TECHNICAL MEMORANDUM

Re: **RI Phase 3 Modification No. 2**
Nevada Environmental Response Trust Site
Henderson, Nevada
Ramboll Project No. 1690006943-036

Figure
1

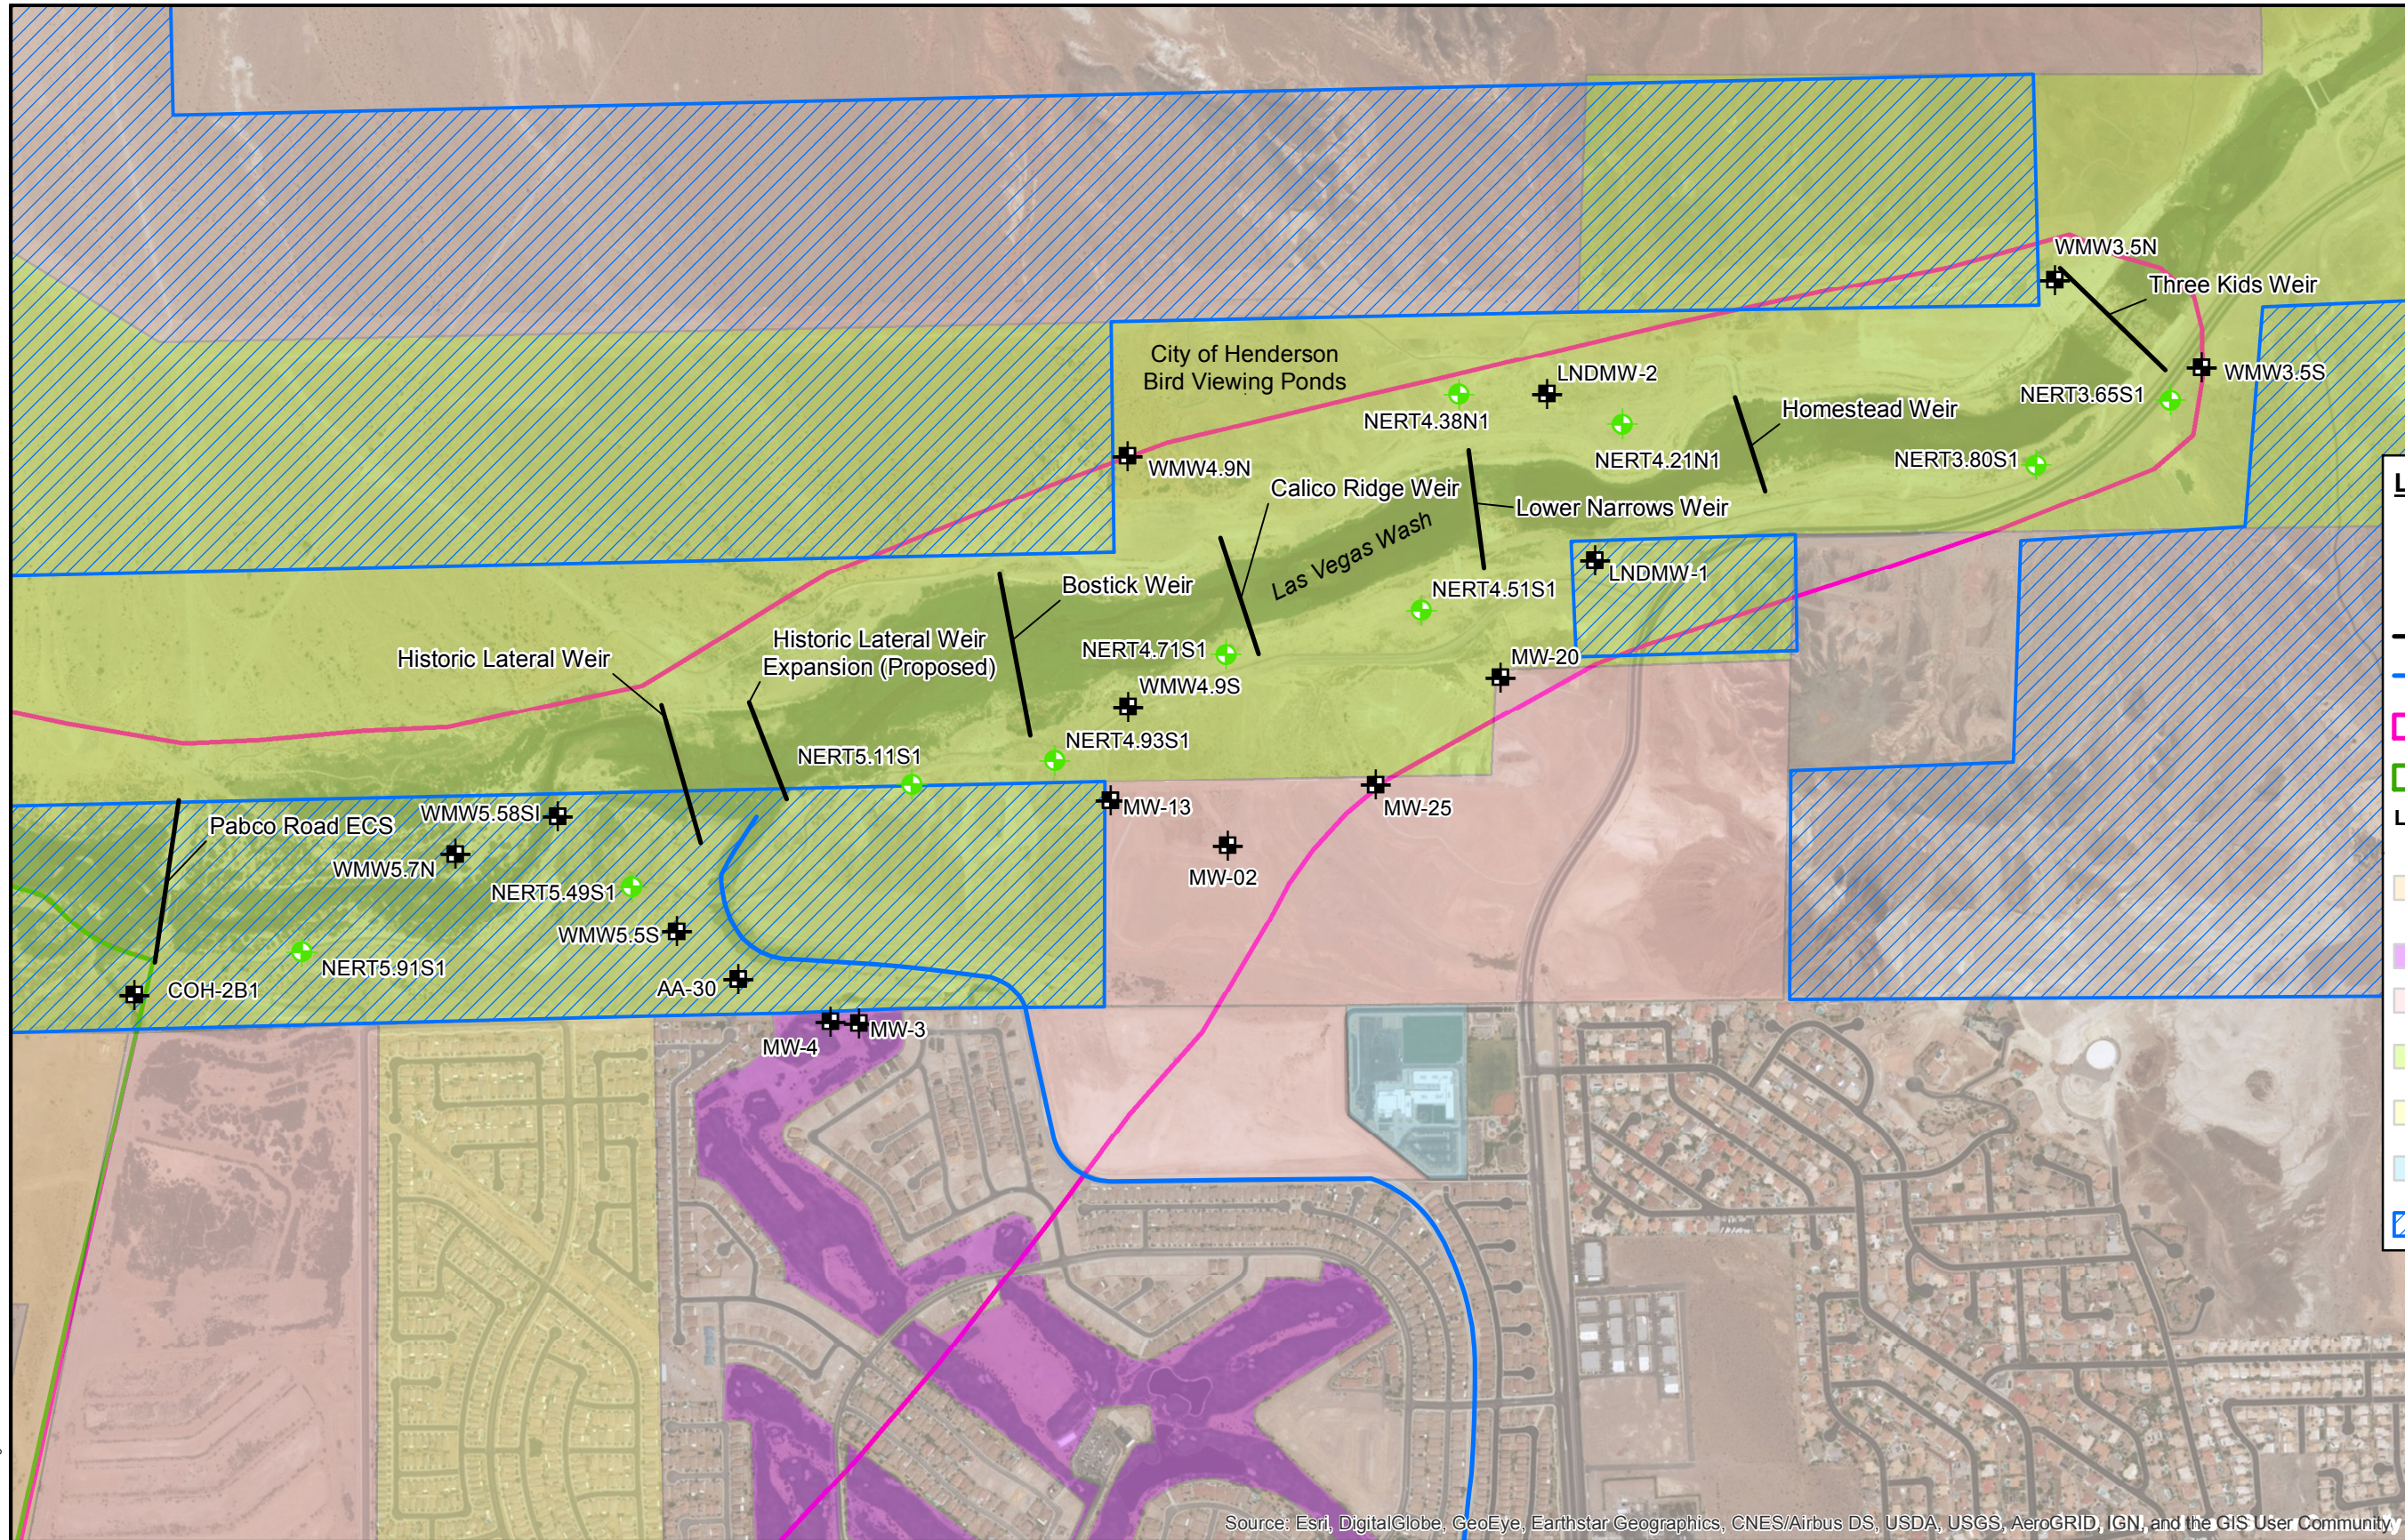
Activity one includes the installation of ten wells (locations NERT5.91S1, NERT5.49S1, NERT5.11S1, NERT4.93S1, NERT4.71S1, NERT4.51S1, NERT4.38N1, NERT4.21N1, NERT3.80S1, NERT3.65S1) on Bureau of Reclamation and Clark County properties (see Figure 1). These well locations were originally proposed in AECOM’s Data Gap Investigation Plan – Phase I Groundwater Monitoring Well Installation (Investigation Plan) within the Downgradient Study Area. At the request of NDEP, the Trust will perform the installation of these wells.

- 1) Drilling activities will be completed by NERT as opposed to AECOM as originally anticipated in the Investigation Plan. As part of this activity NERT will obtain access

from Clark County, obtain all necessary permits to install the wells, and take ownership of the monitoring wells.

- 2) All ten borings will be drilled to a depth of 90 feet below ground surface (bgs) or refusal, whichever comes first, rather than depths of 40-70 feet bgs outlined in the original Investigation Plan. This change is designed to define the vertical extent of contamination along the Las Vegas Wash (LVW) and obtain critical data to be used in determining the need for deeper wells along the LVW. The wells will be completed consistent with the original Investigation Plan (i.e., using the same screened intervals).

- 3) Soil samples will be collected every 10 feet bgs for laboratory analysis (perchlorate, chlorate, total chromium and moisture content), to a total depth of 90 feet bgs. The original scope of work did not include soil sampling but recent sampling indicates the presence of perchlorate in soil along the LVW to depths of 70 below grade. The field geologist will select a subset of soil samples for physical tests including grain size distribution, porosity, bulk density, and fraction organic carbon (foc) to support soil descriptions and dissolved mass calculations. This modification will provide additional information on the distribution of contaminants in the subsurface outside of the screened interval and is consistent with the sampling program for the Phase 3 RI Work Plan within the Northeast Sub-Area (Ramboll Environ, 2017).

Existing Northeast Sub-Area Wells
 Phase 3 RI Work Plan, Modification No. 2
 Nevada Environmental Response Trust Site
 Henderson, Nevada

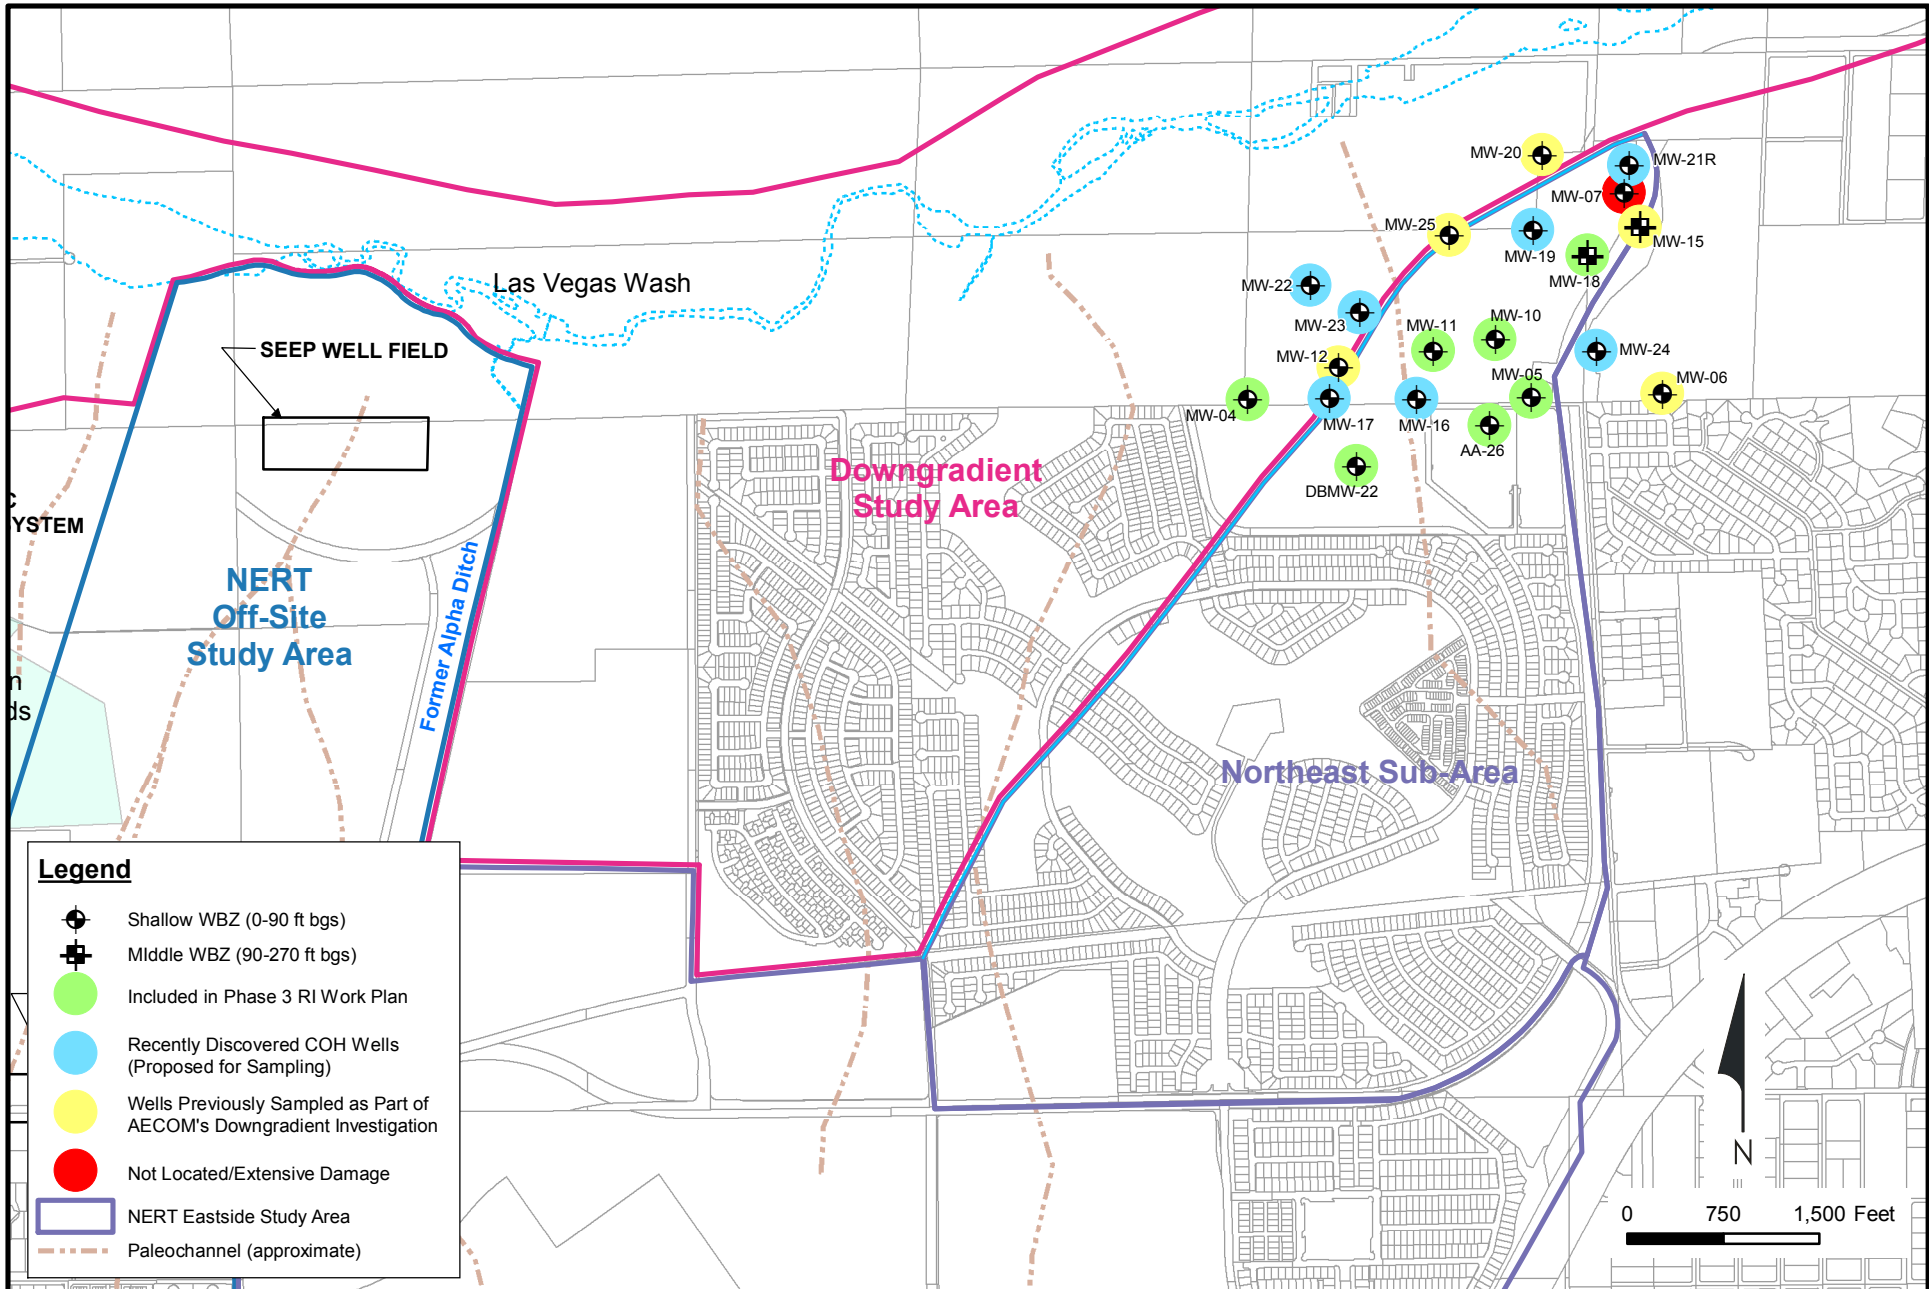
Seven City of Henderson (COH) wells (M-16, MW-17, MW-19, MW21R, MW-22, MW-23, and MW-24) were identified during Ramboll's recent inspection of known wells located within the COH landfill area conducted in early March (see Figure 3). These wells were not included in the Phase 3 RI Baseline and Eastside Study Area sampling events as their existence was unknown until access to the COH landfill property was recently obtained. As approved by NERT, Ramboll proposes to add these seven wells to the Eastside Study Area sampling event currently underway.

In addition, Ramboll proposes to add five COH wells previously sampled by AECOM as part of their Downgradient Study Area Investigation (MW-06, MW-12, MW-15, MW-20, and MW-25) to the Phase 3 RI Eastside Study Area sampling event to provide a more comprehensive analytical data set for the Northeast Sub-Area.
